- Subject** ▶ Change of Inner Flange 40
- For Models** ▶ 5007B, 5007NB, 5007NBA, 5007NH, 5007S, 5026D, 5036D, 5046D, 5057KB, 5611D, 5620D, 5621D, 5621RD, 5630D, 5820, BLS712, BSS730, LS0711B, LS0713, LS0713F, LS711D, M513, M514, M517
- Country** ▶ All countries except Canada, U.S.A., Chile, Mexico, Panama, and European countries.
Note: This technical information applies to the products using Inner flange 40 of 20mm(13/16") arbor.
- Description** ▶ Inner flange 40 has been changed as illustrated below.

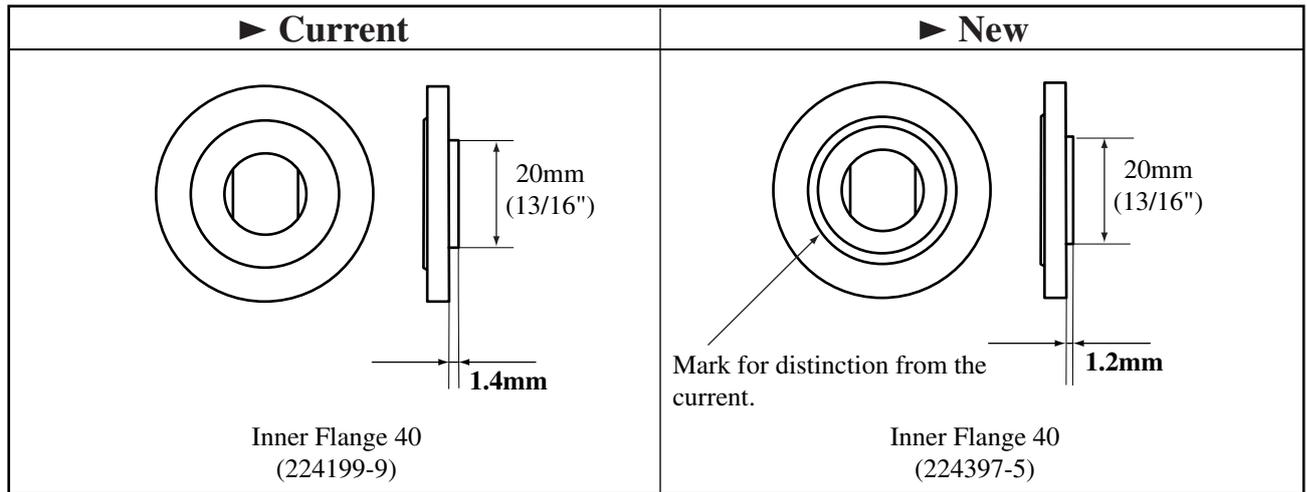
| Item No. | Current part | | Q'ty | I/C | New part | | Q'ty | Note |
|------------|-----------------------------|--|------|-----|-----------------------------|--|------|------|
| See below. | Inner Flange 40 224199-9 | | 1 | ← | Inner Flange 40 224397-5 | | 1 | |

The arrow ← means that the new part is substituted for the current.
